<b>Docket Number:</b>	97-AFC-02C
<b>Project Title:</b>	Sutter Power Plant Application for Certification
<b>TN #:</b>	200833
<b>Document Title:</b>	SEC Response to Formal DR 1-6
<b>Description:</b>	Response to DR 1-6
<b>Filer:</b>	Sarah Madams
<b>Organization:</b>	CH2M HILL
<b>Submitter Role:</b>	Applicant Consultant
<b>Submission Date:</b>	10/11/2013 11:45:09 AM
<b>Docketed Date:</b>	10/11/2013

**Subject: Sutter Energy Center (97-AFC-2C), Data Requests 1 through 6**

## Petition to Amend #6

### Response to Formal Data Requests 1–6

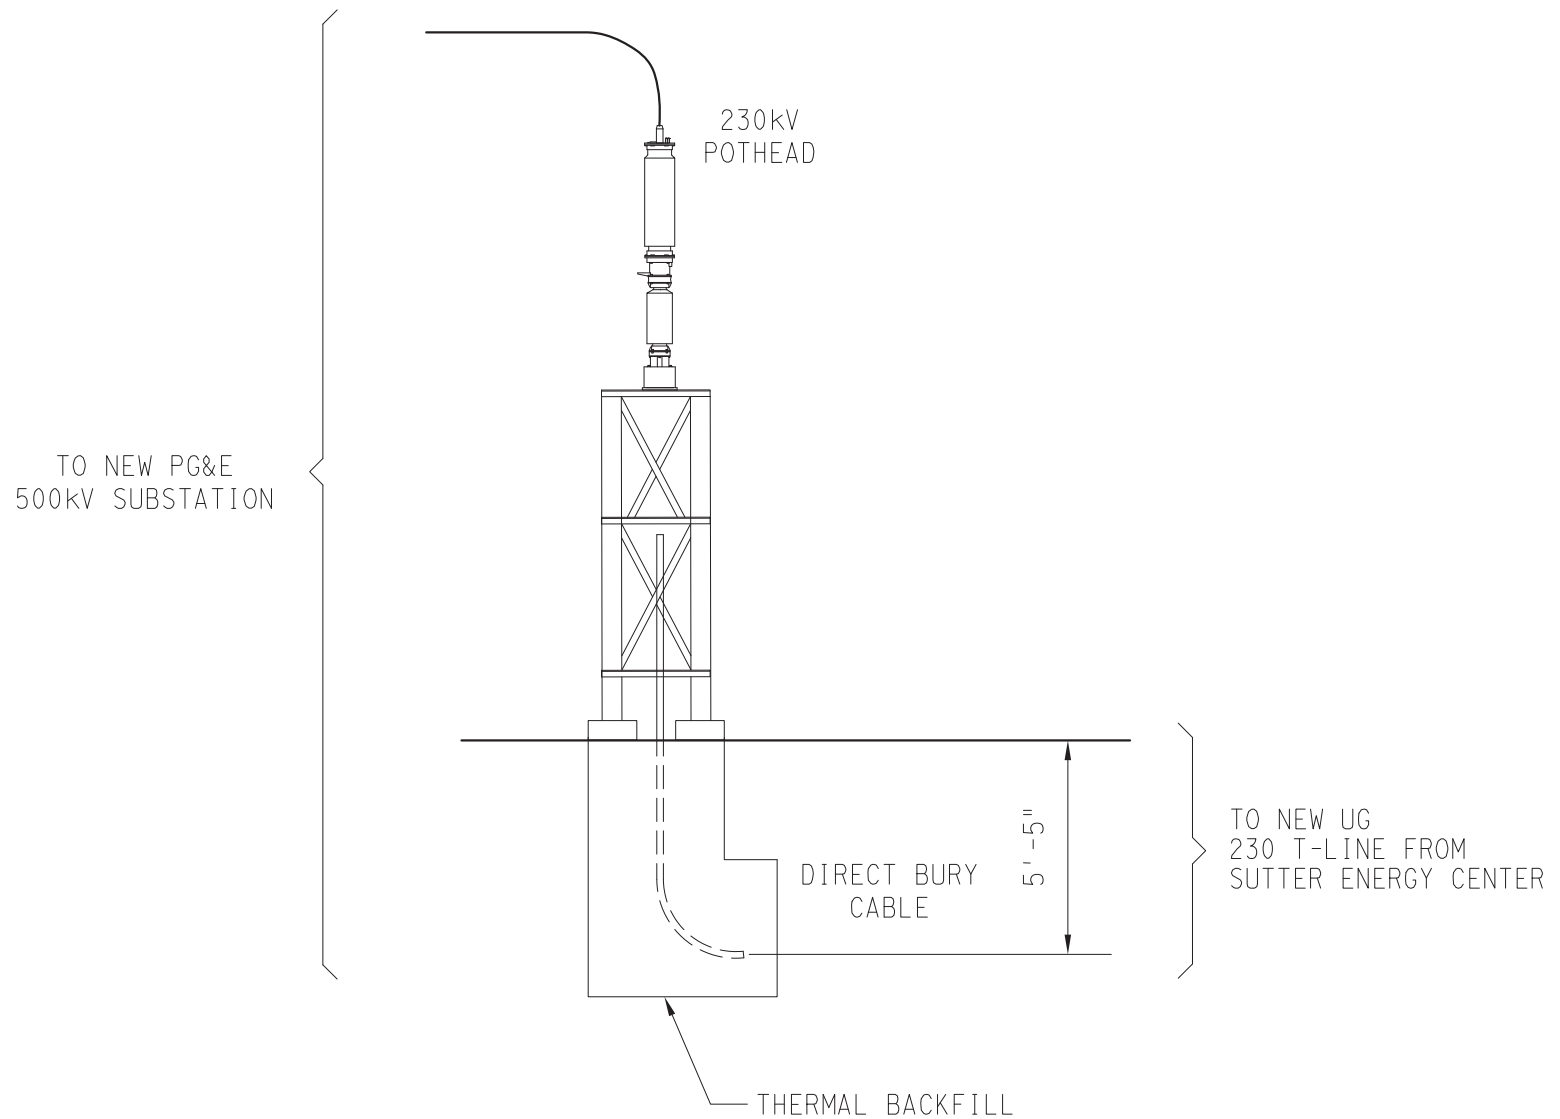
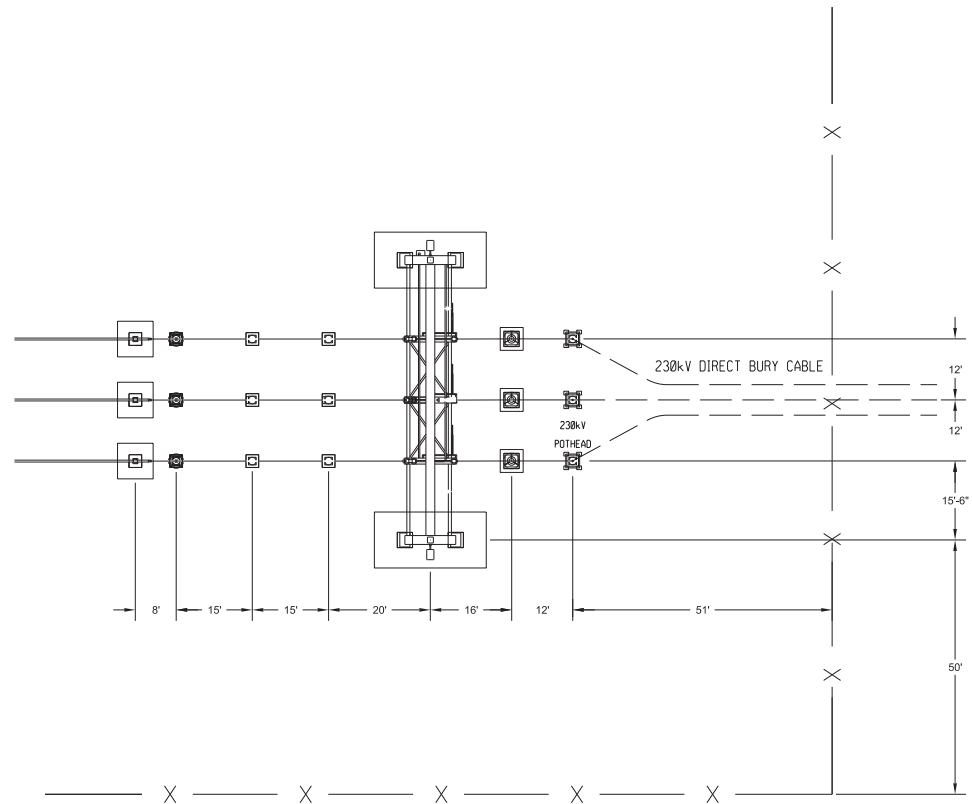
1. *Please provide a one-line electrical diagram of the proposed 500/230-kV substation to be constructed by PG&E adjacent to the existing PG&E Table Mountain-Tesla 500-kV overhead (OH) to connect to the new 500/230-kV transformer bank to be constructed by the applicant. The one-line diagram should show transmission outlets for connections to the 500-kV line and to the new 230-kV underground (UG) cable generator (gen-tie) line, along with the configuration of high- and low-side buses, breakers, and disconnect switches, and their respective sizes and/or ratings. Provide also the ratings of the 500/230-kV transformer bank in the diagram.*

**Response:** As design has not yet begun by PG&E on the substation, a conceptual one-line diagram for a sample 500 kV switching station has been provided as Figure DR1-1.

FIGURE DR2-1  
**500 kV Substation End of Proposed  
 230 kV Underground Transmission Line**  
*Sutter Energy Center*

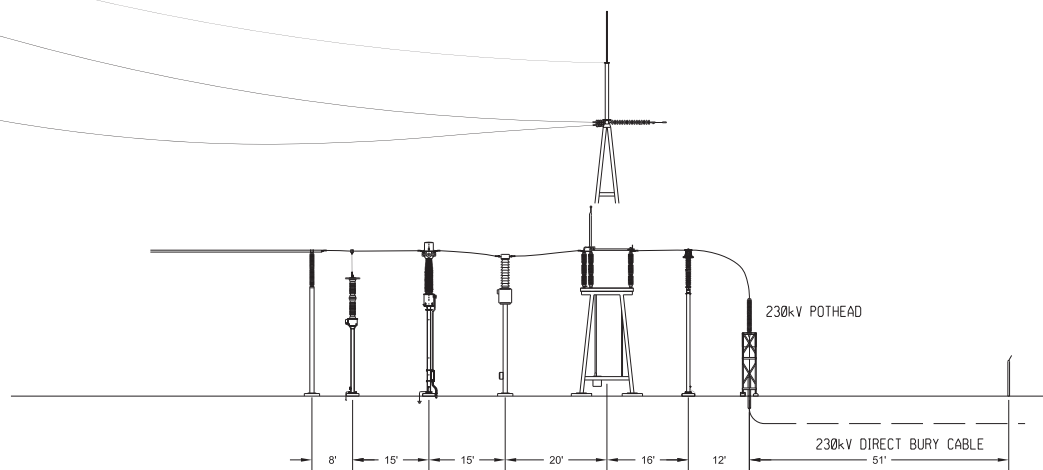
2. *Please provide a physical layout drawing of the proposed PG&E 500/230-kV substation showing the fence lines, all major equipment, and the transmission outlets to the PG&E Table Mountain-Tesla 500-kV OH line, along with their respective routes and lengths and the locations of the additional structures between the substation and the Table Mountain-Tesla 500-kV line. Should the proposed 230-kV UG cable gen-tie line be terminated on a steel pole/structure at the 500/230-kV substation, please also submit the design drawing of the cable termination pole/structure.*

**Response:** As design has not yet begun by PG&E on the substation, a conceptual physical layout drawing of the substation is not yet available. Figure DR2-1 illustrates the 230-kV underground cable gen-tie line termination pole/structures that the project owner will construct adjacent to the 500 kV substation. Figure DR2-2 shows the cable termination structures on the SEC switchyard end.

**FIGURE DR2-2**  
**230-kV Underground Cable Gen-tie Line**  
**Termination Pole/Structures**  
*Sutter Energy Center*

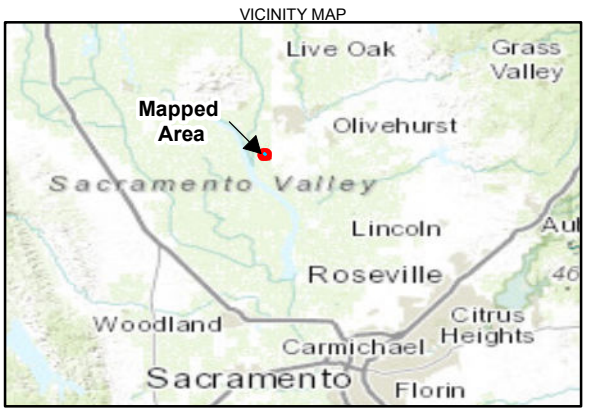
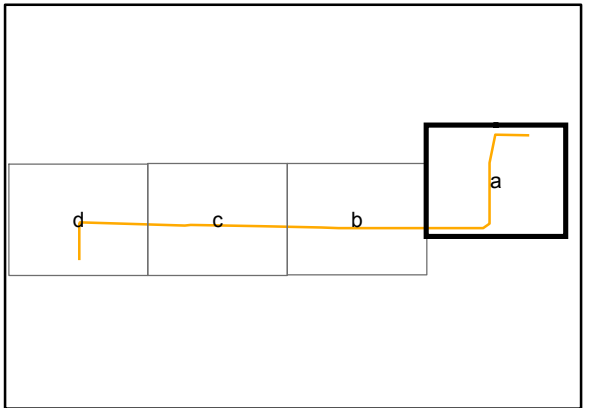
4. *Please provide the conductor size and type of the 230-kV cable gen-tie line. Also provide a design drawing of the 230-kV UG cable Duct Bank construction, showing the depth and width below the ground surface, the layout plan of concrete-embedded PVC conduits, and their spacing for drawing power, communication, and grounding cables. Also submit the drawing for the cable termination pole/structure at the SEC 230-kV switching station.*

**Response:** The 230 kV cable gen tie line is anticipated to use 2000 KCMIL XLPE conductors. Figure DR4-1 provides the anticipated duct bank construction parameters. Figure DR2-2 shows the 230 kV underground cable gen-tie line termination pole/structures.

**FIGURE DR3-1a**  
**Underground 230-kV Gen-Tie Route**  
*Sutter Energy Center*

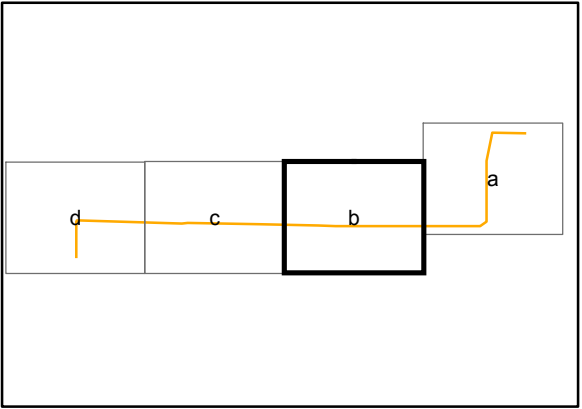
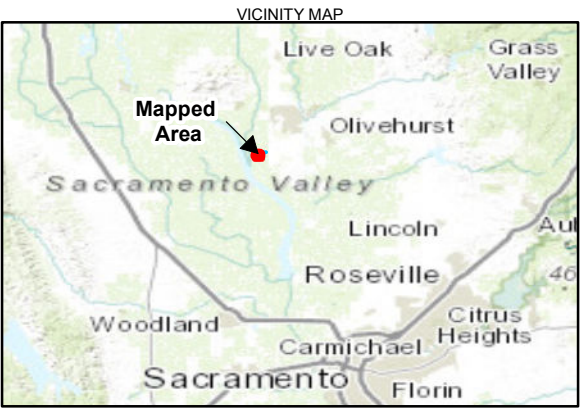
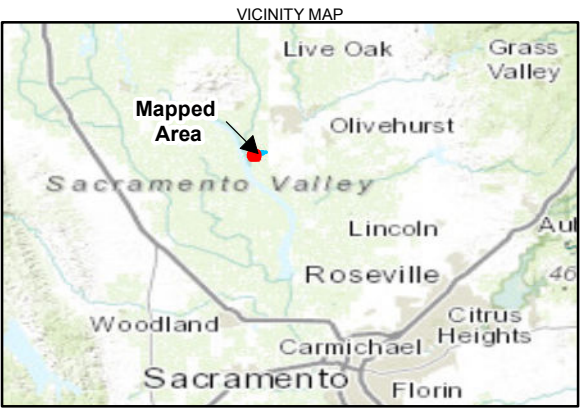
3. *Please provide a discussion and drawing of the physical layout showing distinctly (in a larger scale) the preferred and alternate routes (along any road or land) of the proposed approximately 1.71-mile-long, 230-kV UG cable gen-tie line, including Right of Way (ROW) width(s) between the existing SEC 230-kV switchyard and the new PG&E 500 kV/230-kV substation. Describe whether the ROW would go through any private or public lands.*

**Response:** Figures DR3-1a-d identify the preferred route of the proposed 1.71 mile-long 230 kV underground cable gen-tie line, including right-of-way widths between the existing SEC 230 kV switchyard and the new PG&E 500 kV substation. No alternate routes are anticipated at this time. Land to the north and south of the underground gen-tie line is privately owned. There are public lands belonging to the US Fish and Wildlife Service to the east of the new PG&E 500/230 kV substation, but the underground gen-tie line would not cross them.

**FIGURE DR5-2**  
**Aerial view of the SEC Switchyard**  
*Sutter Energy Center*

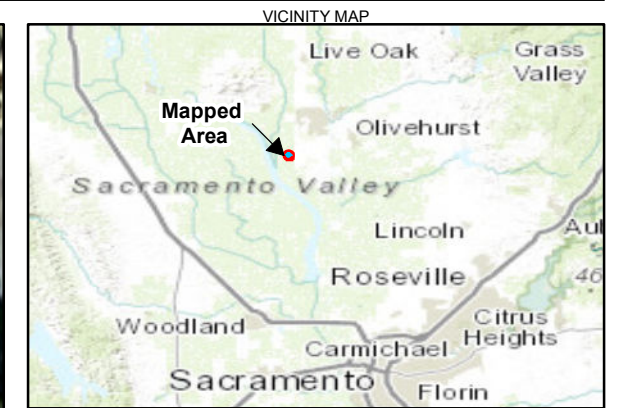
5. *Please submit a post-project, one-line electrical diagram of the SEC 230-kV switchyard (for net 600-MW maximum generation output to the ISO grid), showing the generator step-up transformers and the configuration of switchyard 230-kV buses, breakers, and disconnect switches on the 230-kV side, with their respective sizes and/or ratings, and the proposed UG gen-tie line transmission outlet. Also provide a post-project physical layout diagram of the SEC 230-kV switchyard, showing the fence line, all major equipment, and the proposed UG gen-tie line outlet*

**Response:** Equipment within the existing SEC 230 kV switchyard will not change due to the proposed changes, with the exception that the switchyard will tie into the new 230 kV underground gen-tie line instead of the current aboveground line. Both the underground gen-tie line and the aboveground line exit the plant on the southwest corner. A one-line diagram identifying this change is provided as Figure DR5-1. Figure DR5-2 provides an aerial view of the existing switchyard, fenceline of the switchyard and the location of the proposed underground gen-tie line outlet.
